Well Name: PETE MORROW	Well Location: T25N / R12W / SEC 1 / NWSW / 36.427902 / -108.067307	County or Parish/State: SAN JUAN / NM
Well Number: 1	Type of Well: OTHER	Allottee or Tribe Name:
Lease Number: NMSF078064	Unit or CA Name:	Unit or CA Number:
US Well Number: 3004527240	Well Status: Gas Well Shut In	Operator: DJR OPERATING LLC

Type of Submission: Notice of Intent	Type of Action: Plug and Abandonment
Date Sundry Submitted: 01/14/2022	Time Sundry Submitted: 01:51
Date proposed operation will begin: 01/14/2022

Plug and Abandonment Procedure
for
DJR Operating, LLC
Pete Morrow 1
API # 30-045-27240
NW/SW, Unit L, Sec. 1, T25N, R12W
San Juan County, NM

AFMSS 2 Sundry ID 2652640

DJR Operating, LLC Proposed Wellbore Diagram

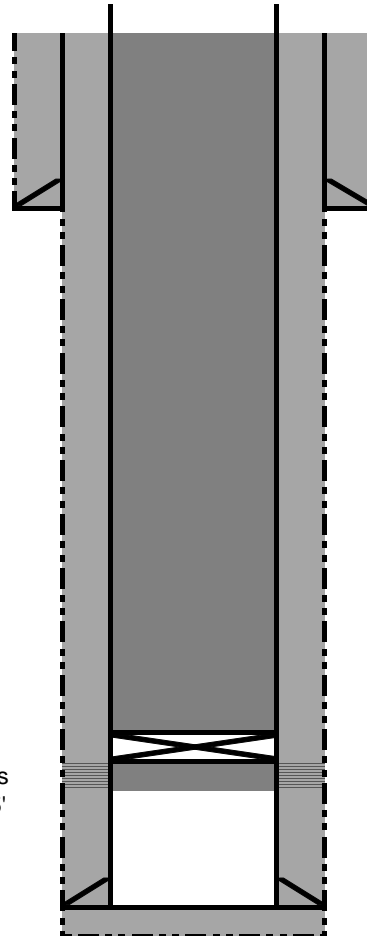
You are also required to place cement excesses per 4.2 and 4.4 of the attached General Requirements.
